TC-2022-237

Brief Communication: Rapid ~335 10⁶ m³ bed erosion after detachment of the Sedongpu Glacier (Tibet)

2nd revisions in response to referees

Response to Referee #2, Max Van Wyk de Vries

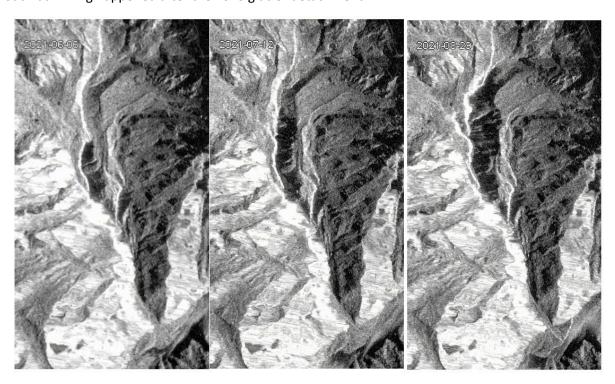
Finally, the new supplementary material is very useful and should be discussed in a little more detail. The Sentinel-1 timeseries shows the rapid unzipping of the landscape in a way that is not currently captured in the manuscript. In addition, the period of rapid change in the delta within the Tsangpo from June to Aug 2021 provides some clues into when sediment was being delivered to this river. I would like to see 1-2 more sentences describing this. I am not sure if there is space for a new figure in the manuscript, but showing the following three images really highlights the processes occurring during the period between the two DEMs (e.g. below). Maybe it could be a figure in the sup mat and referred to directly.

We replaced Fig 3 (profiles) with Sentinel-1 images, added the profiles in a small version to Fig 2, added the full-size profiles to the Supplement and added text in the main paper: "The Sentinel-1 image time series over summer 2021 (Fig. 3 and animation in the Supplement) shows rapid changes of the Sedongpu fan in extent, shape and height, but still these changes appear rather minor compared to the 279±5 10⁶ m³ erosion volume that should have entered the fan during this time period."
